## Product Change Notification

### PCN-ICC-9099-2023

| Business Unit            | Product Line Code | Type of Change              | Action                        | Date of Issue |
|--------------------------|-------------------|-----------------------------|-------------------------------|---------------|
| ICC - Industrial Cabinet | BE1               | Product Change Notification | Notify Distributors and Field | 10/18/2023    |

#### Description for Product Change Notification

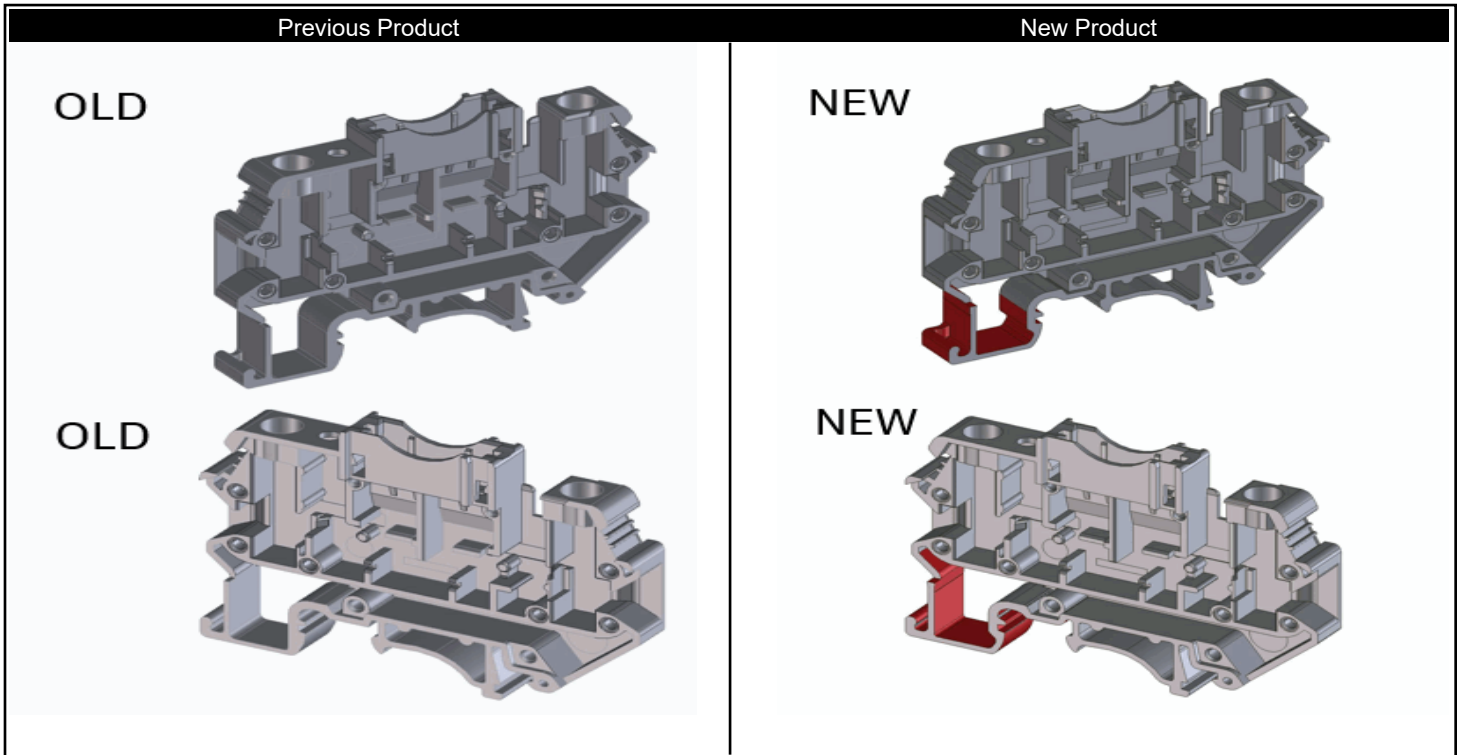
Modification of the foot geometry to improve the mounting process on the DIN rail in terms of forces and haptics. The change will have no impact on the products functionality. Overall dimensions of the product will not be impacted by this change.
